ITEM: VILLAGE OF DOWNERS GROVE PARKING FACILITY
PROJECT #14-00

PURPOSE: To authorize execution of contract Change Orders #8, 9, 10, & 11 for the Village of Downers Grove Parking Facility, Project #14-00

Change Order No. 008 *DRAFT*

Change Order No. 009 *DRAFT*

PARTIAL WATER RETENTION PLAN

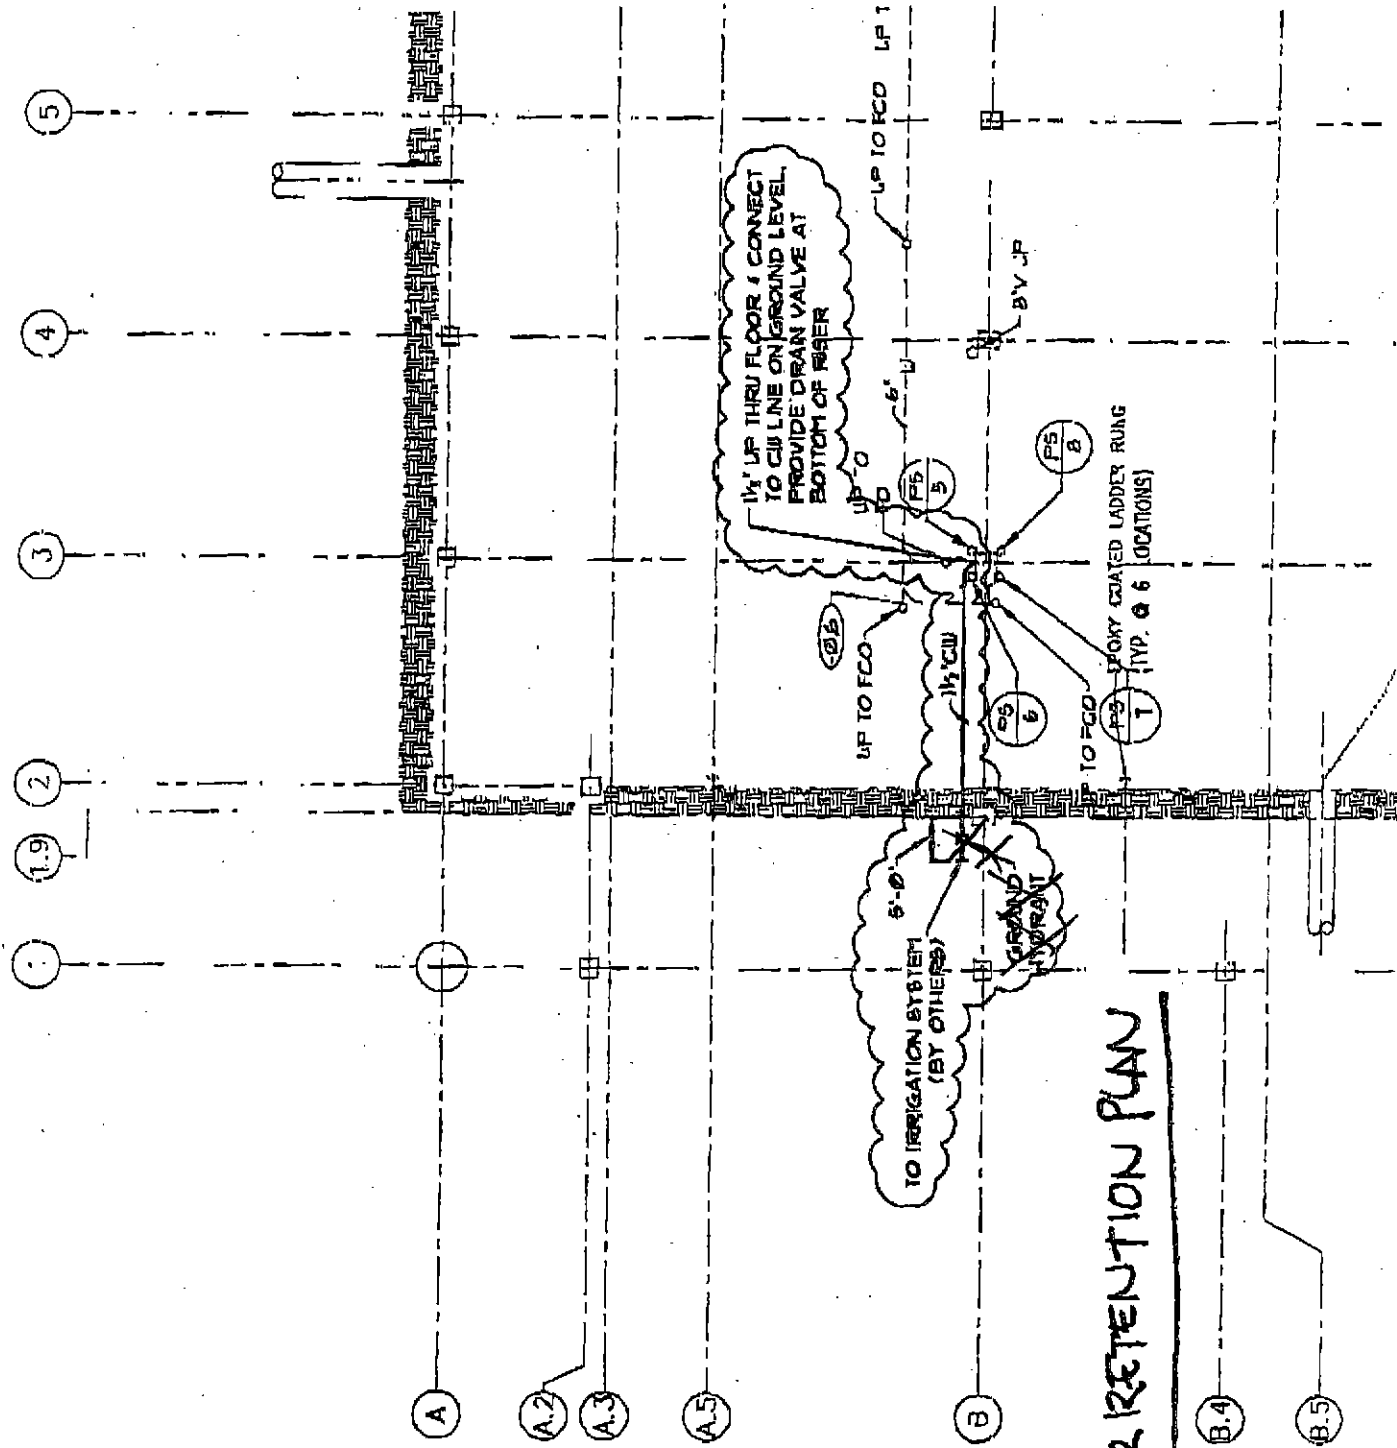
CCD 021

PROPOSED 10" FOOTING DRAIN PERFORATED CLOSED JOINT SEWER PIPE @ 0.40% (SEE SHEET S101 FOR CONTINUATION) INV. @ BULD.=697.03

SECTION THROUGH TREE PIT PERPENDICULAR TO STREET

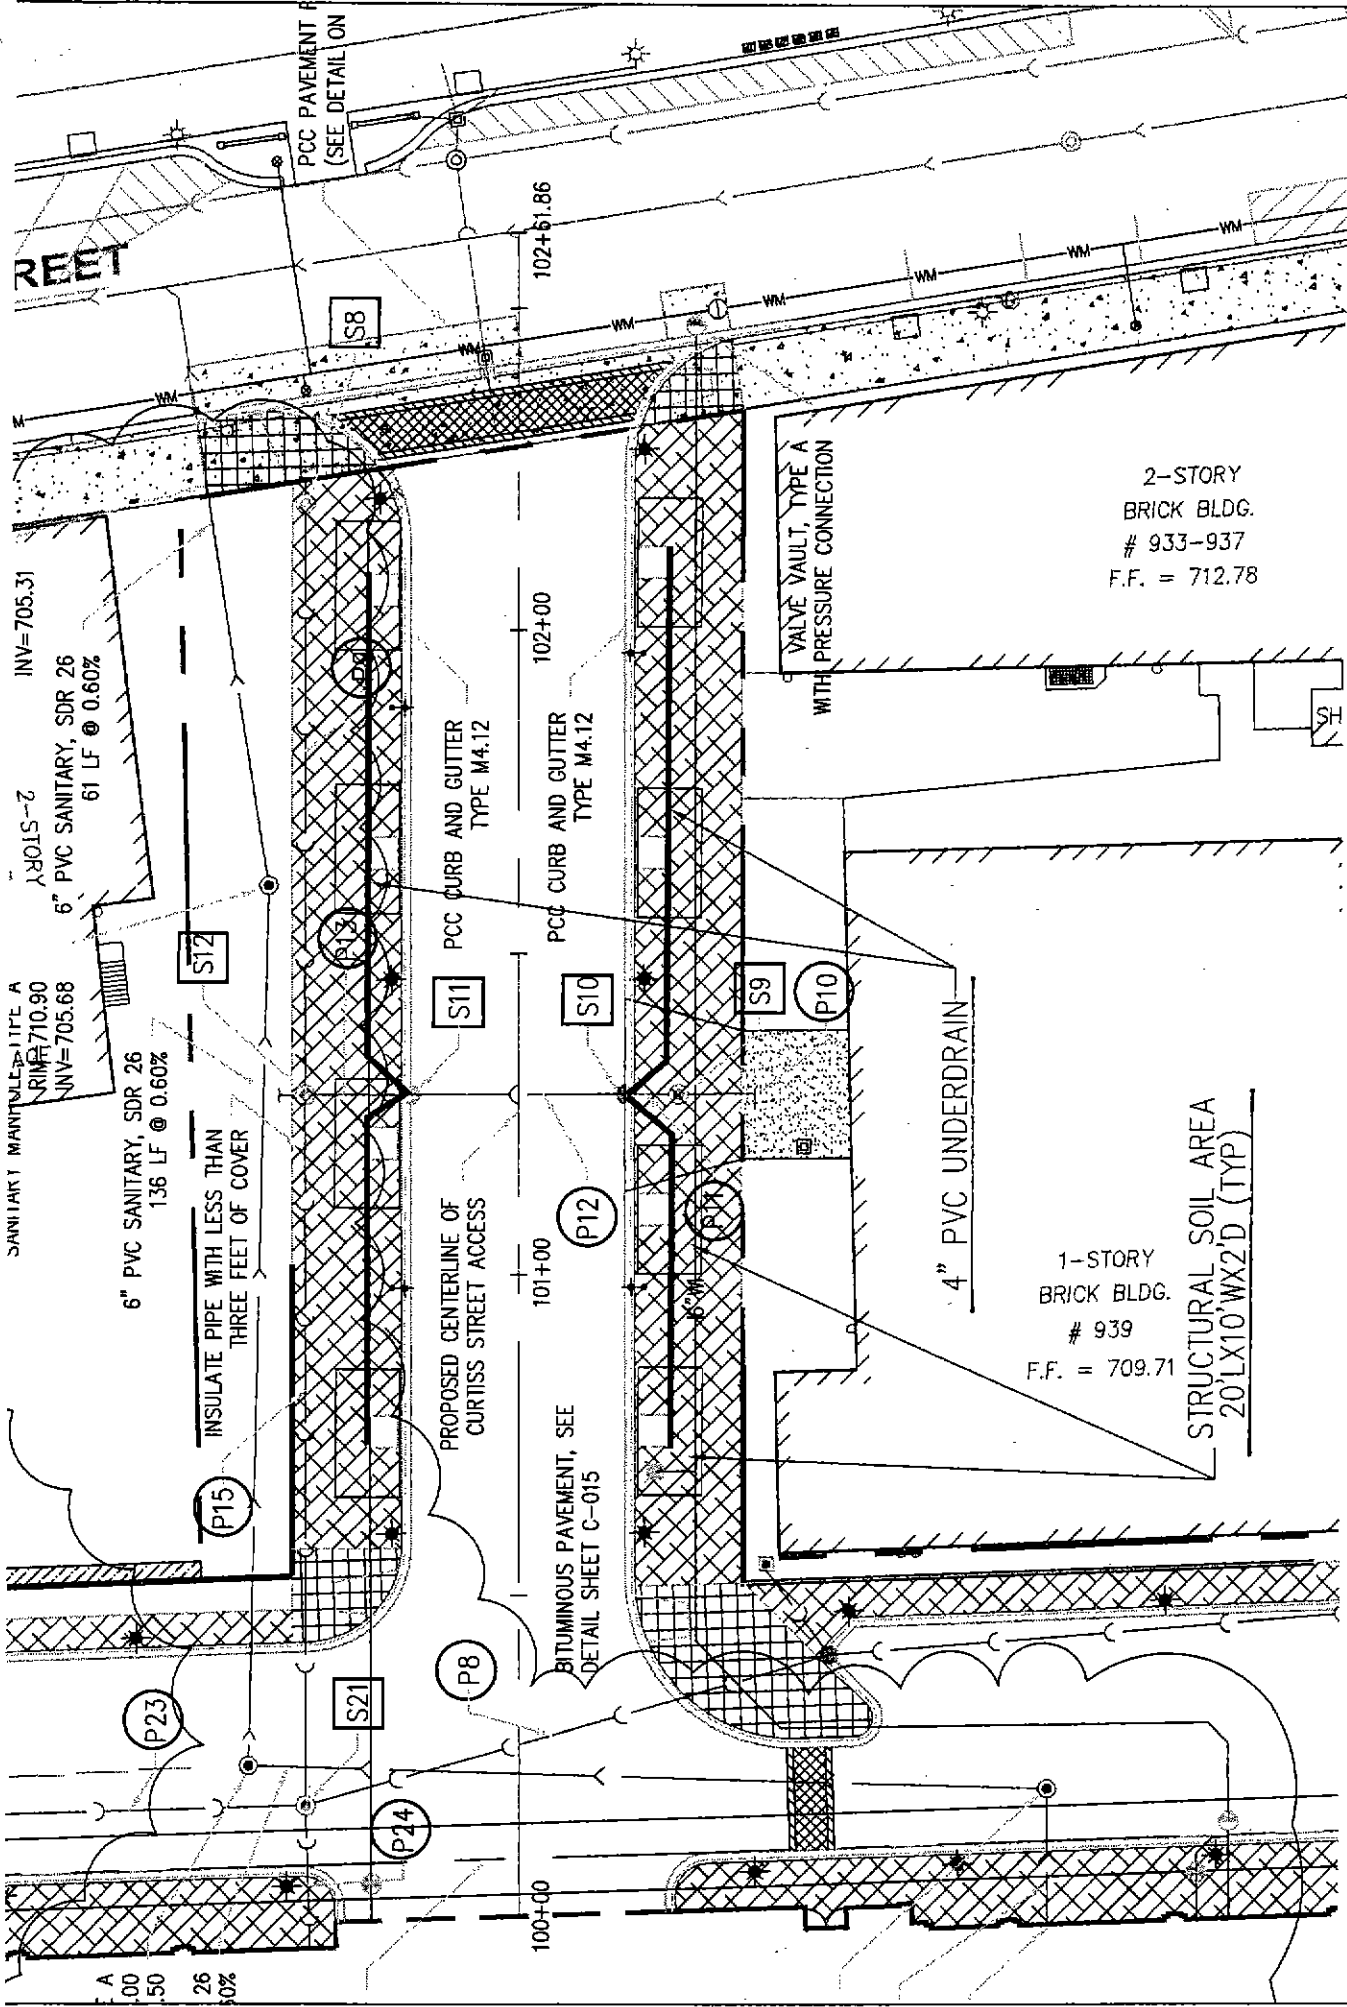
Item B provides standard Village specifications for structural soil, pipe underdrains and fabric-lined trench that pertain to the trees to be planted in the sidewalk per plan. As written, it constitutes approval of Turner's C.O.R. No. 035, based on C.C.D. No. 030, except that the requested 3 days time extension was waived by Turner. Village Staff reviewed Turner's C.O.R. No. 035 and responded that the cost is reasonable. See attached e-mail. Mark-ups were then checked by Benesch and found to be within the Contract Specifications.
Change Order Cost = \$21,502.00

PLACE REGULAR SOIL IN TREE PIT

Dotted lines denote
profile of new
stair landing

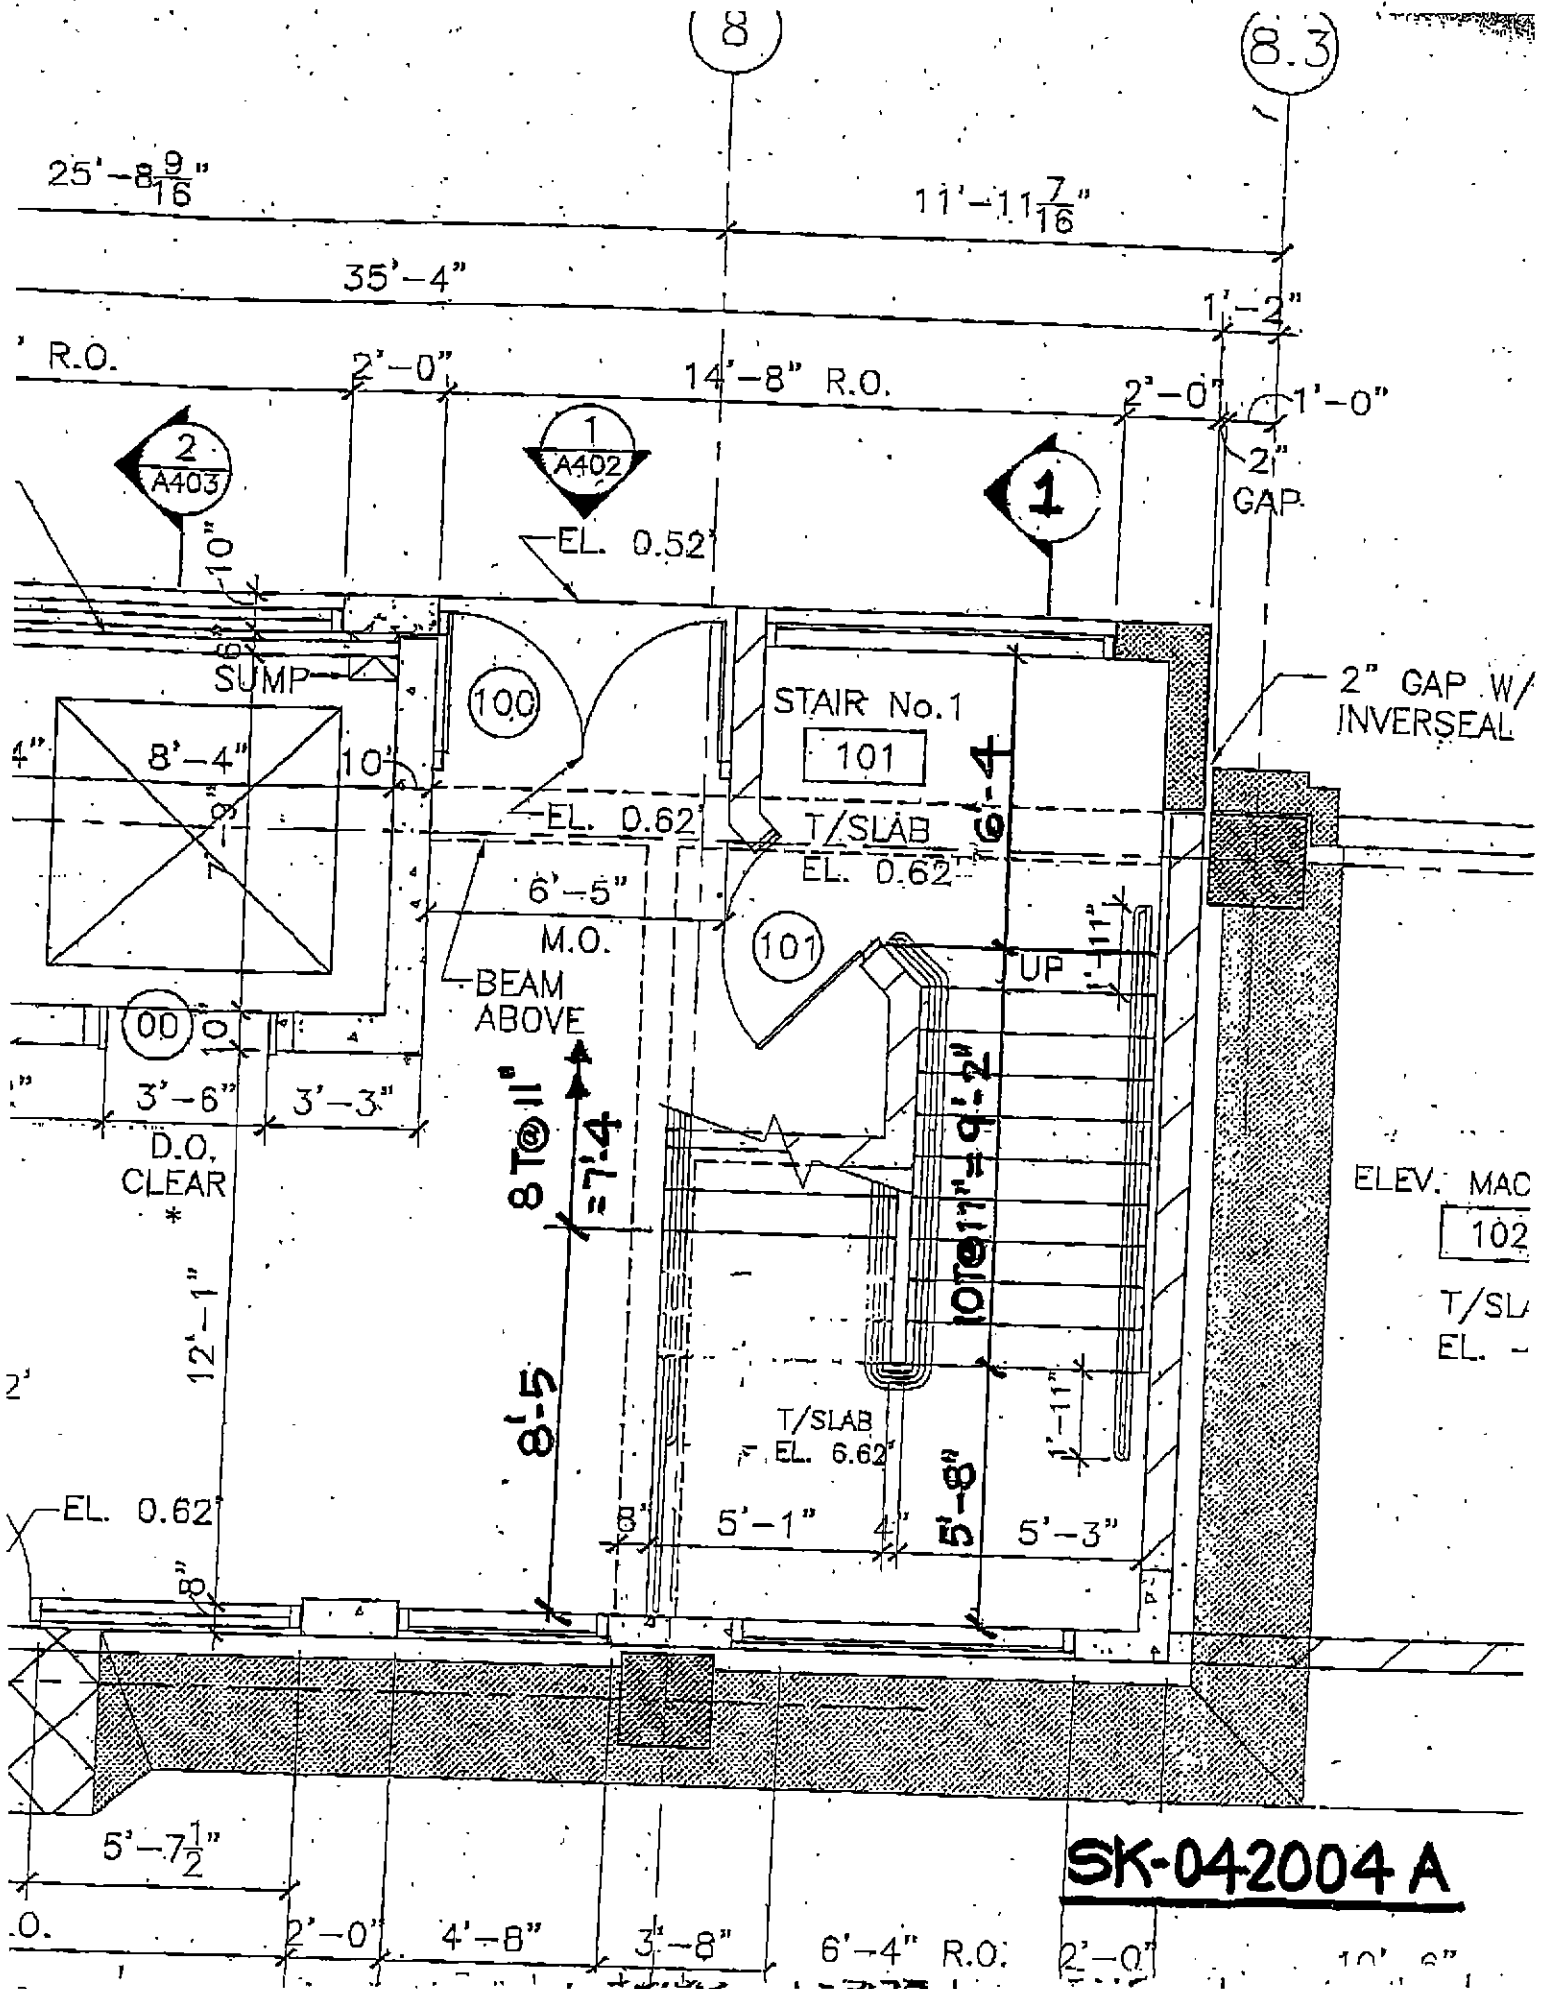
1. On Stair Tower No. 1, remove existing intermediate landing and supporting beam mark B12 (elev. 12.26) and re-construct new intermediate landing & beam at elev. 11.70. This entails provision of additional riser from new intermediate landing at elev. 11.70 to existing second level at elev. 15.08. It also eliminates one riser and lengthen intermediate landing from elev. 6.62 to the new intermediate landing at elev. 11.70 as shown on photo 042004 and sketches SK-042004A, SK-042004B & SK-042004C.

4. Refer to sketch photo 042004 and SK-042004G to reconstruct new stair landing at new elev. 11.70.

Existing,
EL. 12.26'
NEW T/Bm.
EL. 11.70'
B/Landing
EL. 10.87'
B/New Bm.
EL. 9.70'

SK-042004D

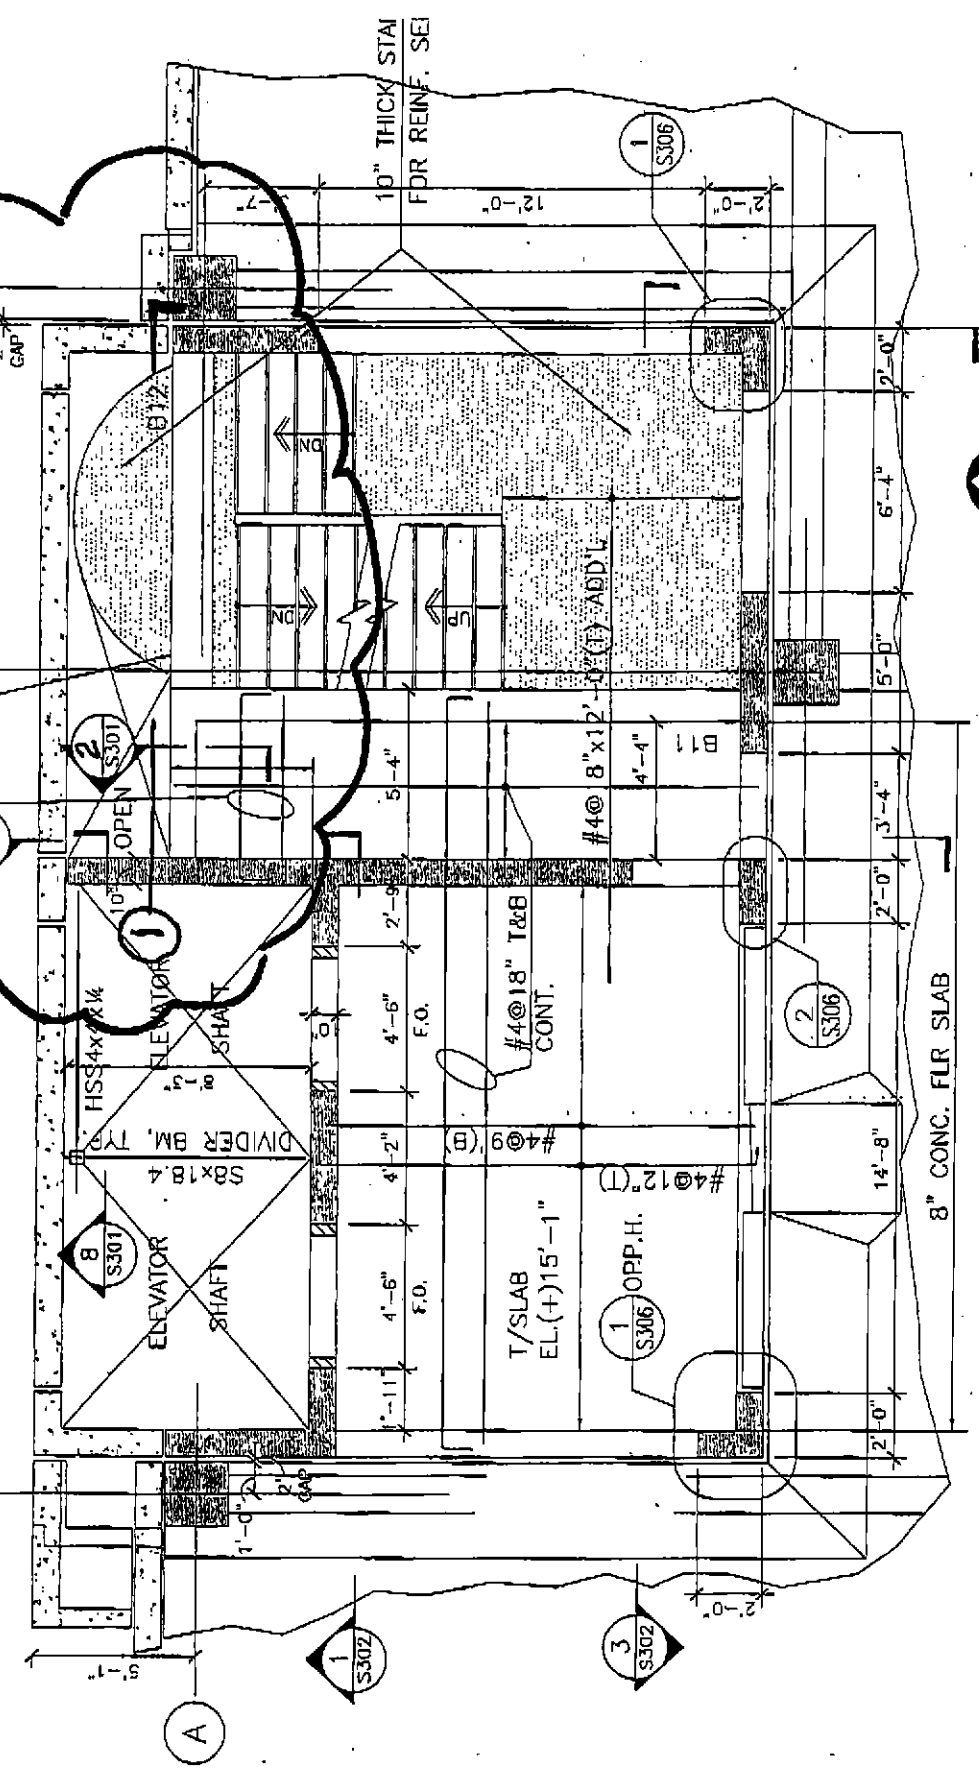
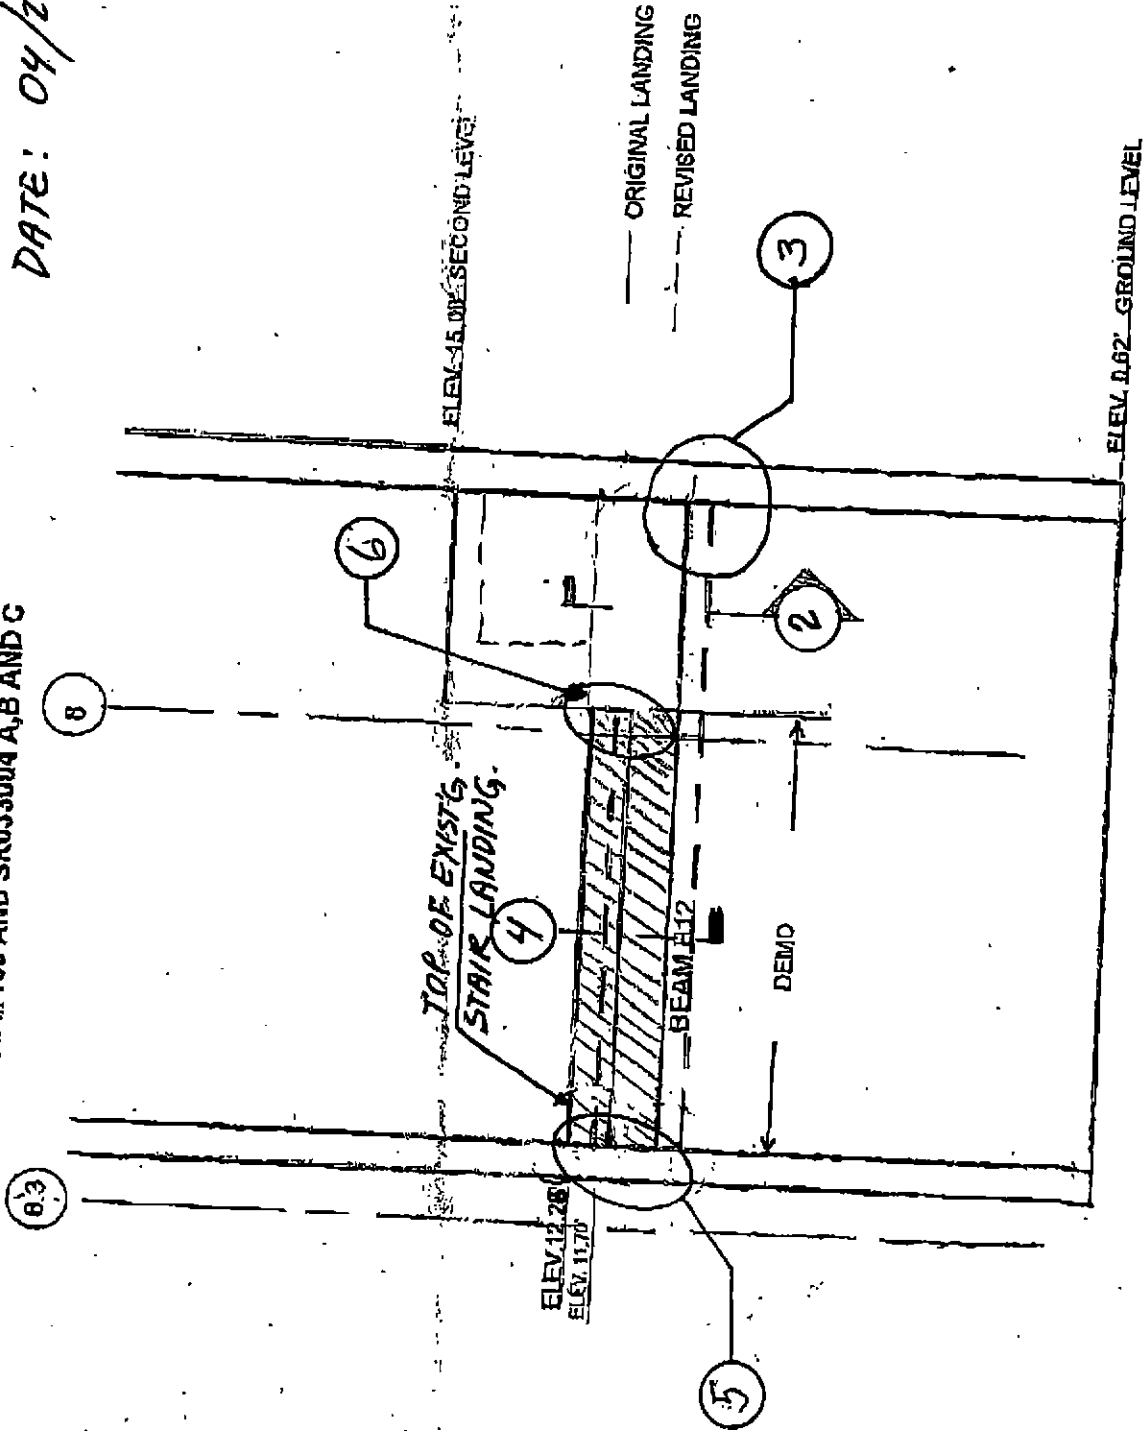
STAIR #1 - REVISED STAIR LANDING
SEE RFI#166 AND SK033004 A,B AND C
